Access Compliance Report

Public Rights-of-Way

Intersection ID: 27006	Main Street: ORCHID_HILL_LN	Cross Street: RED_MAPLE_DR	Location: S
ADA ID: A2991732ABEC	Ramp Type: PerpDiag	Initial Pass/Fail: Fail	Overall Compliance: No
		Severity Score: 50

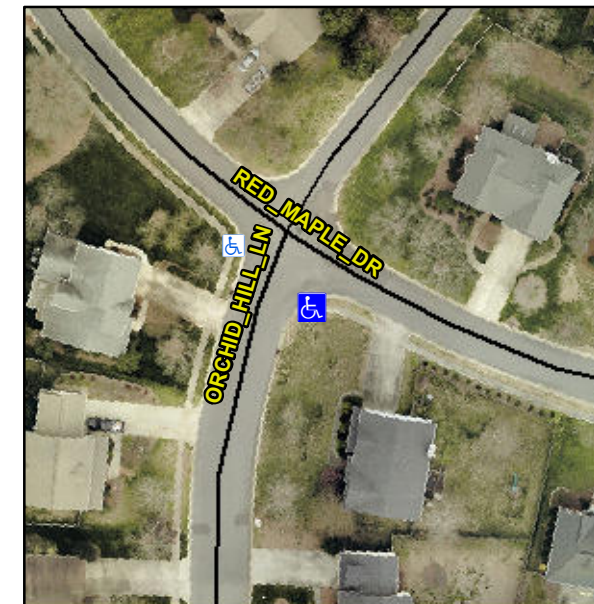
R304.2.2, R304.5.3

Compliance	Description	Data	Compliance	Description	Data
N/A	Ramp Length (in)	95.0	No	Ramp Slope (%)	17.6
Yes	Ramp Width (in)	48.0	No	Ramp XSlope (%)	14.6
N/A	Flare Type LT	N/A	N/A	Flare Type RT	N/A
N/A	Flare Slope LT (%)	N/A	N/A	Flare Slope RT (%)	N/A
N/A	Flare Traversable LT?	N/A	N/A	Flare Traversable RT?	N/A
N/A	Landing Length (in)	N/A	N/A	DWS Provided?	N/A
N/A	Landing Width (in)	N/A	N/A	DWS Contrast?	N/A
N/A	Landing Slope (%)	N/A	N/A	DWS Length (in)	N/A
N/A	Landing X Slope (%)	N/A	N/A	DWS Full Width?	N/A
N/A	Landing Curb? (Y/N)	N/A	N/A	DWS Offset (in)	N/A
N/A	Shared Landing?	N/A			
N/A	Gutter Ponding?	N/A	N/A	Gutter Slope (%)	N/A
N/A	Gutter Lip Ht (in)	N/A	N/A	Gutter X Slope (%)	N/A
N/A	Painted X Walk1?	No	N/A	Painted X Walk2?	No
	X Walk 1 Direction	To NE		X Walk 2 Direction	To NW
N/A	X Walk 1 Width (in)	N/A	N/A	X Walk 2 Width (in)	N/A
	X Walk 1 Slope (%)	0.5		X Walk 2 Slope (%)	8.7
	X Walk 1 X Slope (%)	13.1		X Walk 2 X Slope (%)	3.4

Remove & Replace Curb Ramp With Two New Directional Ramps or Equivalent.
